**SUNDRY NOTICES AND REPORTS ON WELLS**  
*Do not use this form for proposals to drill or to re-enter an abandoned well. Use form 3160-3 (APD) for such proposals.*

8. Well Name and No.  
JOHNSON GAS COM B 1

## PLUG AND ABANDONMENT PROCEDURE

CONDITIONS OF APPROVAL

# Johnson Gas Com "B" #1 Proposed P&A

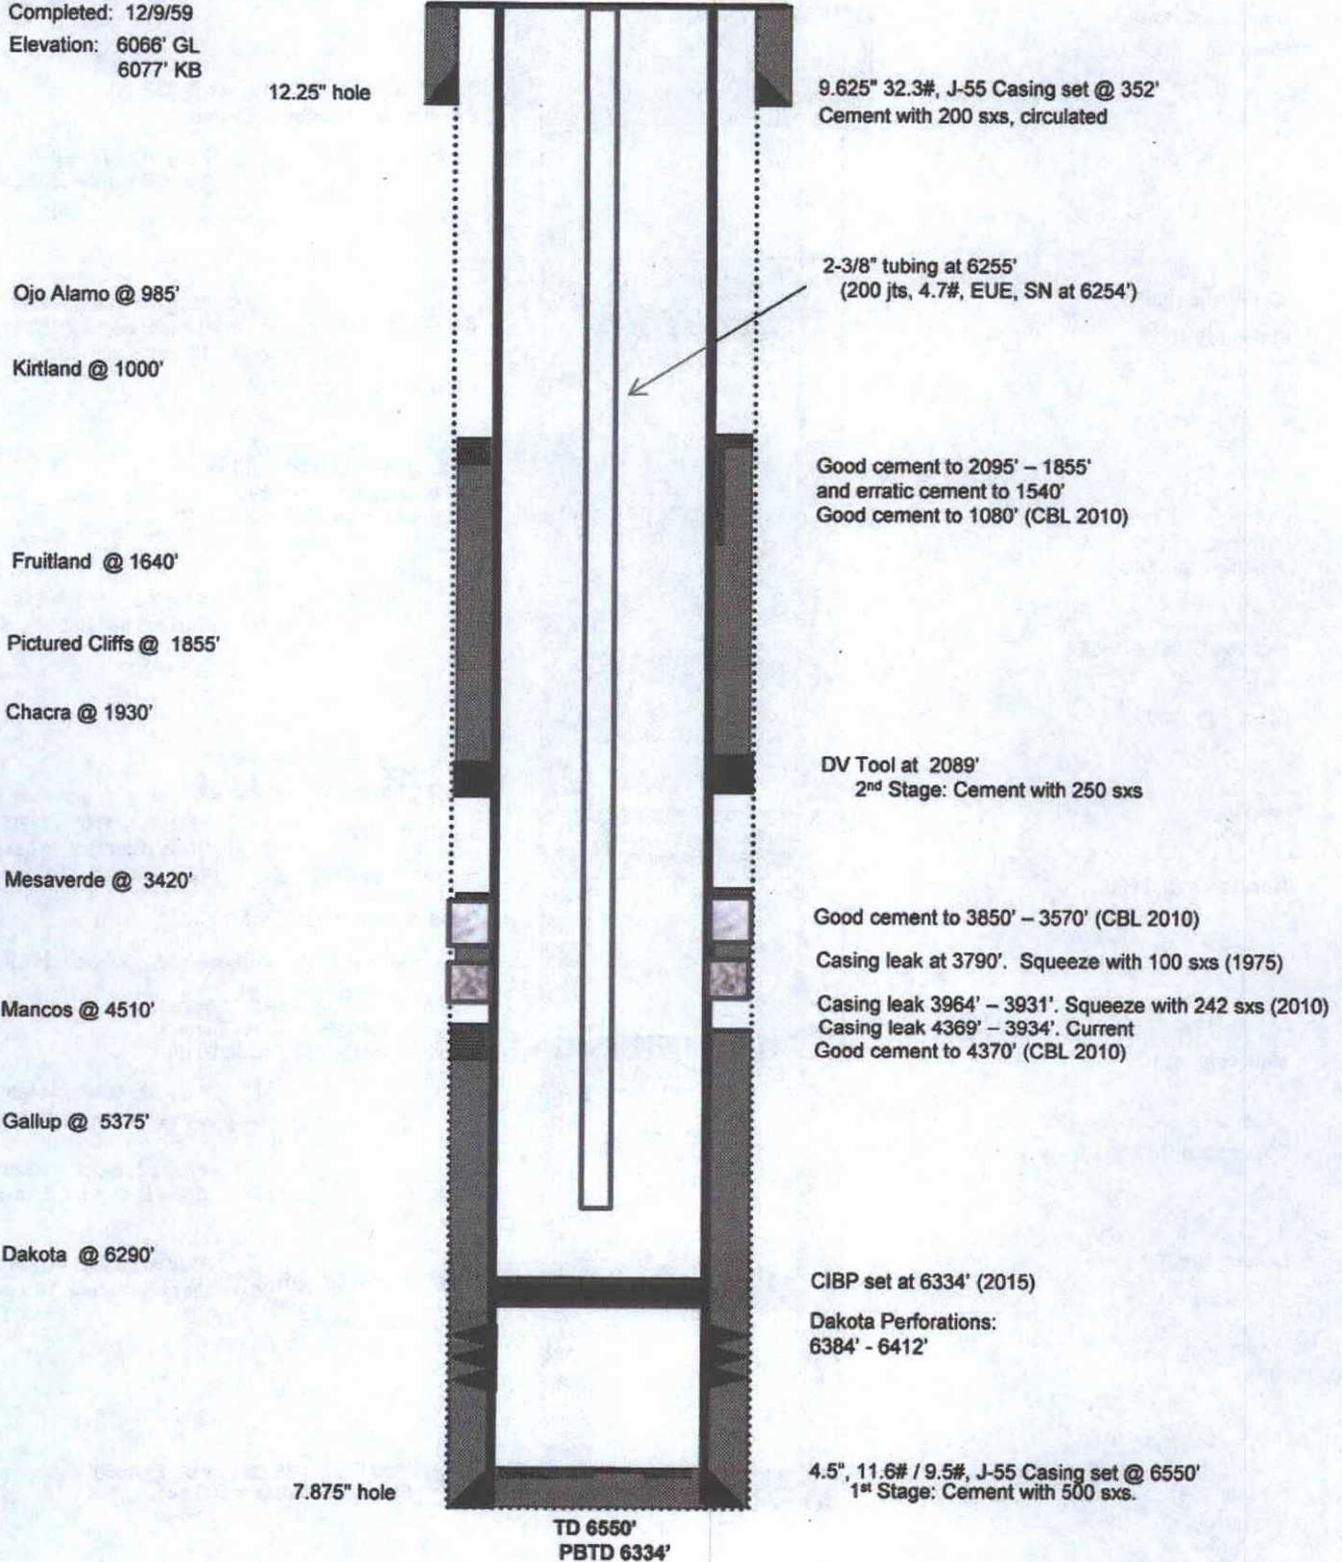
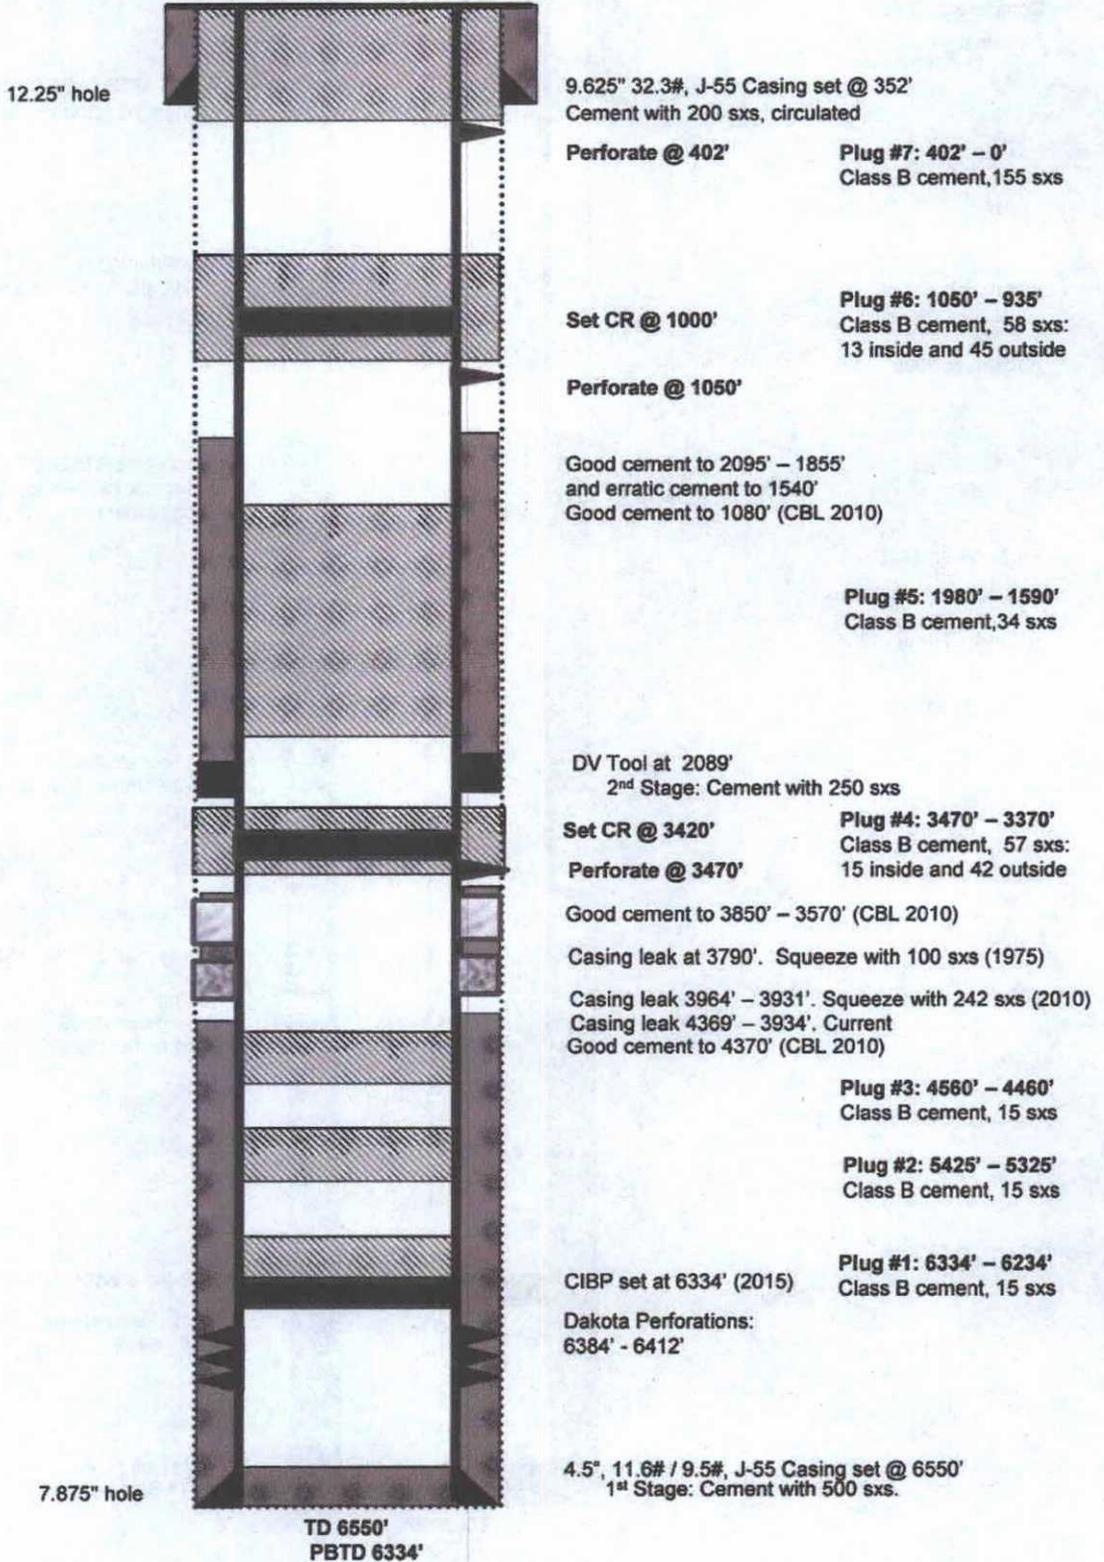
- a) Bring the top of Plug #1 to 6213 ft. to cover the top of the Graneros. BLM picks top of Graneros at 6263 ft. Adjust cement volume accordingly.
- b) Set Plug #3 (4603-4503) ft. to cover the top of the Mancos. BLM picks top of Mancos at 4553 ft.
- c) Bring the top of Plug #4 to 3352 ft. inside/outside to cover the top of the Mesaverde. BLM picks top of Cliff House at 3402 ft.
- d) Bring the top of Plug #5 to 1467 ft. to cover the top of the Fruitland. BLM picks top of Fruitland at 1517 ft. Adjust cement volume accordingly.
- e) Bring the top of Plug #6 to 817 ft. inside/outside to cover the top of the Ojo Alamo. BLM picks top of Ojo Alamo at 867 ft. Adjust cement volume accordingly.
